## QUALITY ASSURANCE -- NON-CONFORMANCE REPORT

**Report No:** NCR-000329

**Reference Description:** Excessive Fillet Weld Size, FB028-012

**Job Name:** SAS Superstructure

Reference Description: Excessive Fillet Weld Size, FB028-012

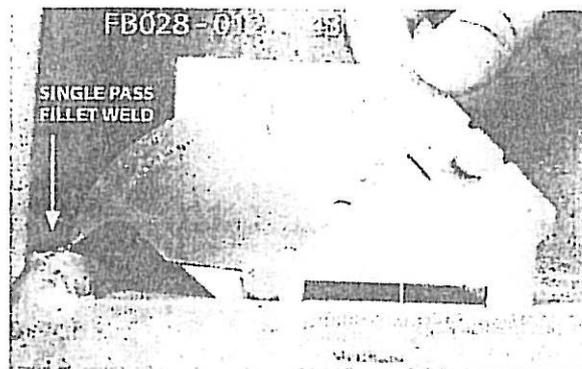
During random in-process visual inspection of Floor Beam FB028-012, Caltrans Quality Assurance (QA)

Inspector observed single pass fillet welds that measured approximately 13mm (welds FB028-012-134 &amp; 143).

The supporting WPS (WPS-B-T-2133) is only qualified for a maximum single pass of 9mm.

Grind welds to appropriate size and perform required NDT.

ZPMC ground the welds specified size and performed the required NDT showing that the welds are in conformance. Also, ZPMC has instructed the shop foremen and QC of the importance of meeting fillet weld size and maintain required heat input values.
